From: Nicola Painter [redacted]
Sent: 26 June 2026 16:53
To: planning.control@north-herts.gov.uk.
Subject: Planning application 26/00851/FPH

CASE REFERENCE NUMBER: 26/00851/FPH

LOCATION: The Glade, The Glade, Letchworth Garden City, Hertfordshire, SG6 3LN,

DESCRIPTION: Installation of first floor timber balcony to side elevation following demolition of existing side element, alterations to fenestration and external rendering. Erection of detached outbuilding and greenhouse following demolition of existing detached outbuilding. Creation of additional vehicular Access.

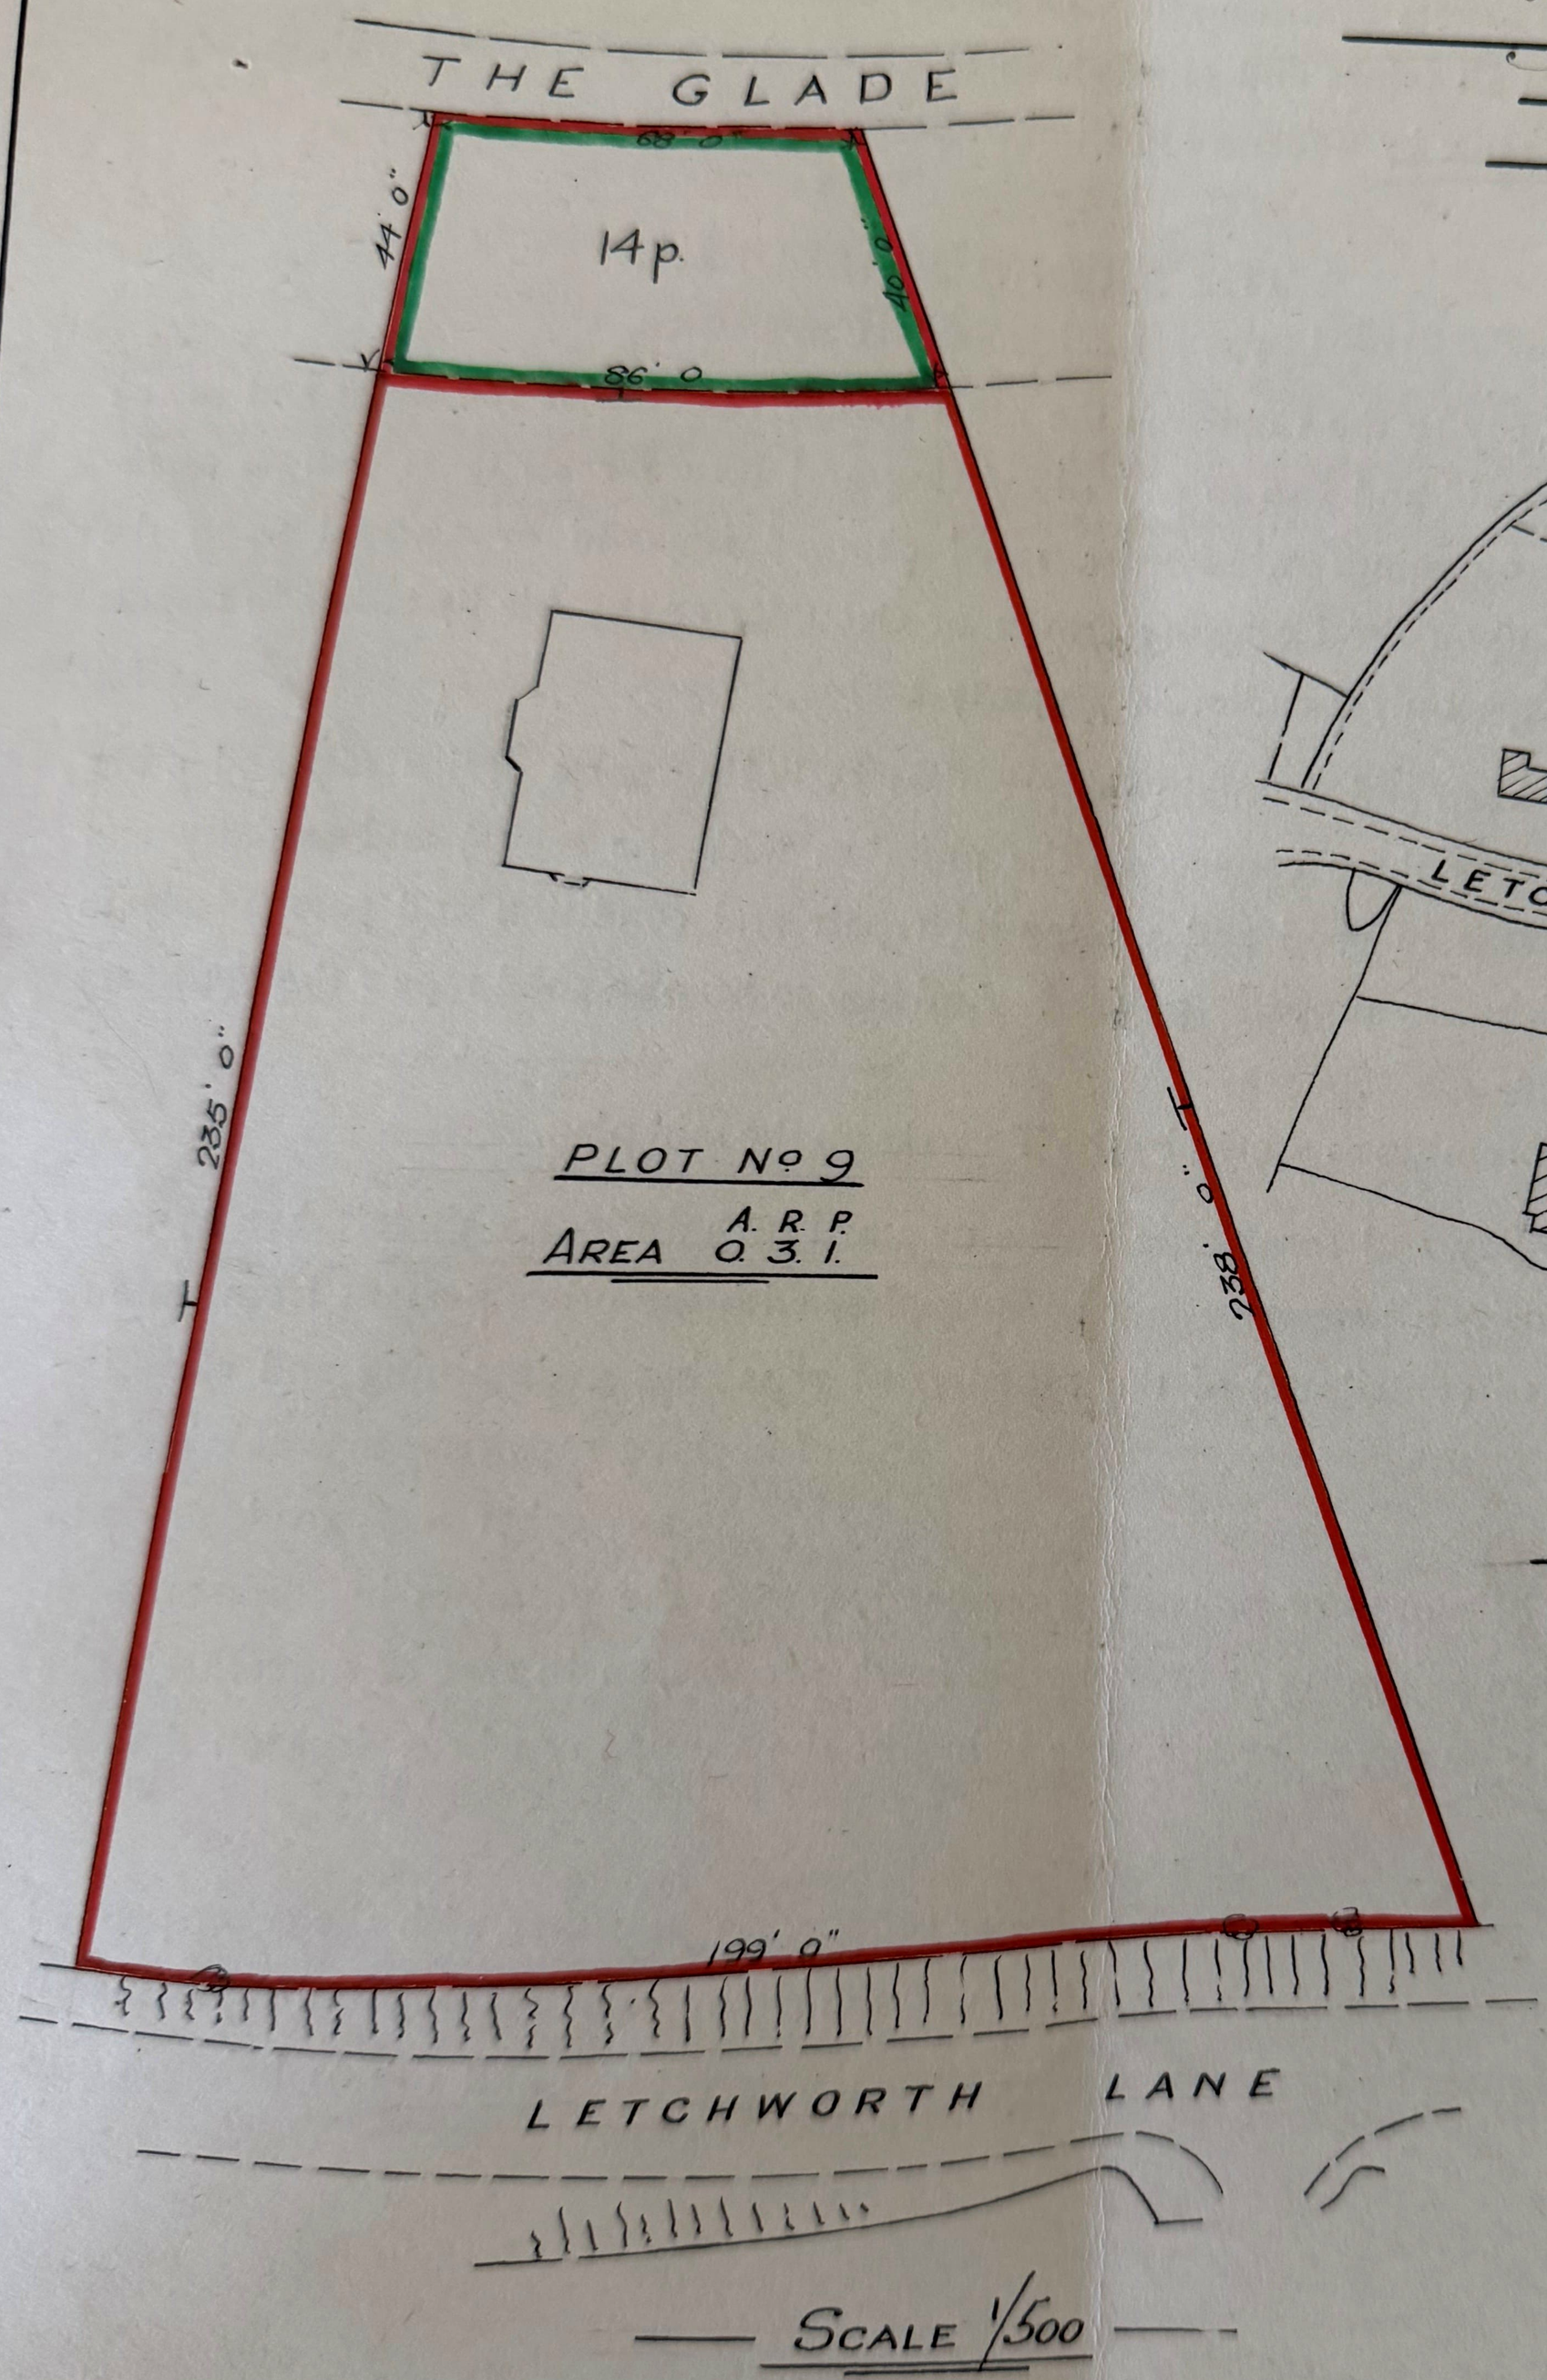
hedge - Laurel - was removed anticipating this application and was done without prior approval from the Heritage or NHDC. In addition to this 4 meter high hedge being previously removed it is now on the current application to remove a extremely established mature tree, which is surely against heritage design principles.

Attached photos show established tree that is proposed to be removed (T10) along with a drawing from our original lease showing the greensward shaded in green
